From: Philip Trueman <ptrueman@hesterarchitects.co.uk>
Sent: 23 July 2021 09:17
To: Richard Phillips
Subject: RE: Morrisons, 41-67 High Street, Yiewsley - 2370/APP/2021/67
Attachments: NBS Yiewsley hard landscape works 08.03.21.pdf; 0811.1.2 YIEWSLEY PLANTING PLAN GROUND FLOOR LEVEL 08.03.21.pdf; 0811.1.4 YIEWSLEYGROUND FLOOR HARD LANDSCAPE 08.03.21.pdf; 0811.1.5 YIEWSLEY PLAY AREA 08.03.21.pdf; 16128 - 530C - Proposed Materials.pdf; 0811.1.1 REV A YIEWSLEY PLANTING PLAN - DECK LEVEL 22.07.21.pdf; 0811.1.3 REV A YIEWSLEY HARD LANDSCAPE DECK LEVEL 22.07.21.pdf; 0811.1.6 REV A YIEWSLEY LANDSCAPE DETAILS 22.07.21.pdf; NBS Yiewsley Soft landscape specification Rev A 22.07.21.pdf; YIEWSLEY LANDSCAPE MANAGEMENT PLAN REV A 22.07.21.pdf; 16128 - 2 - 630 - Privacy Screen Details.pdf; 16128 - 2 - 631 - Podium Privacy Screen Details.pdf; 16128 - 743 - Balcony Privacy Screen - Details.pdf

Condition 10 – Privacy Screens

CONDITION 5: Materials and external surfaces (ref. 2019/2880)

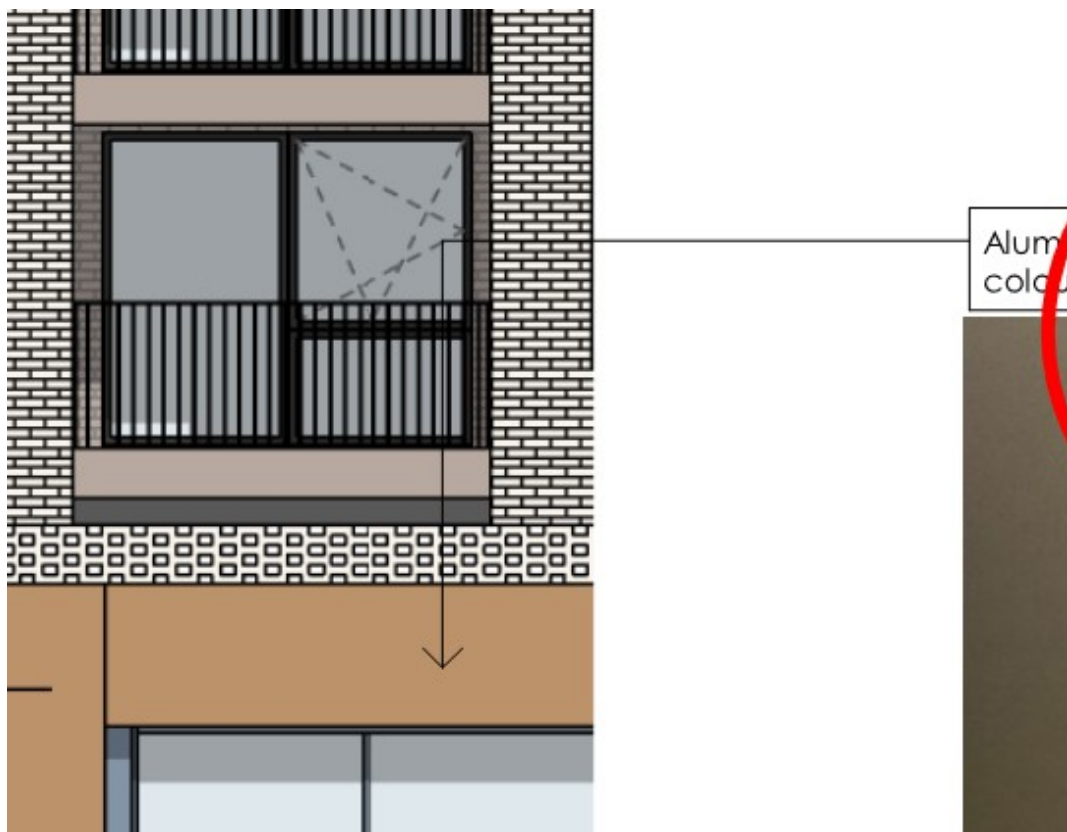
Hester drawing 2-910 Rev A provides a plan with colour-coded hard surfacing. The last item on the schedule is J (Deck paving) - no deck paving is indicated on plan.

Clarification is required regarding the whereabouts of the deck paving on site? No information available regarding the external walls / boundary treatments.

The Type J deck paving is used on the upper amenity deck – please see attached – **Yiewsley Hard Landscape Deck Level.**

In reviewing the materials submission we have noticed that one of the RAL references is incorrect – as below – so we have attached a revised drawings **16128 - 530C Proposed Materials** to correct this.
